Subject: RE: La Crosse County Surveyor - For Review - CSM - Causeway Blvd 17-20251-15

The proposed Causeway Boulevard CSM has been reviewed. See comments below.

Attached for your review is a Certified Survey Map for 17-20251-15 in the City of La Crosse. Please let me know if you approve or have any comments.

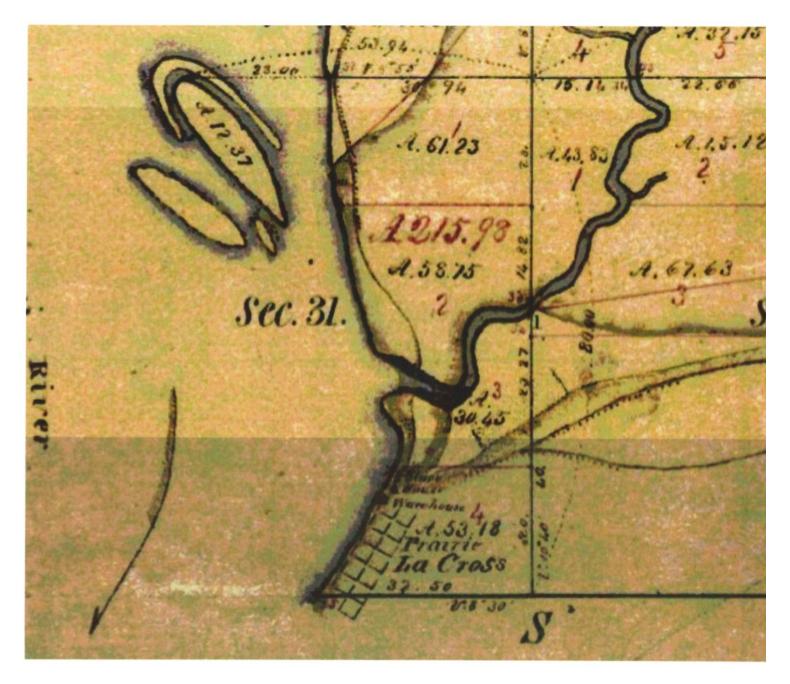
1. The caption on all four pages, along with the opening statement in the legal description states "located in the Northwest ¼ of the Northeast ¼". That statement is incorrect. There is no Northwest ¼ of the Northeast ¼ in Section 31. It is only Government Lot 1 as per the Original Government Plat Sheet (below). I realize that the plat of River Point District indicates that it is part of the Northwest ¼ of the Northeast ¼, but that is simply not true. Register of Deeds, Robin Kadrmas indicates that she only has tracting for Government Lot 1 in this area.
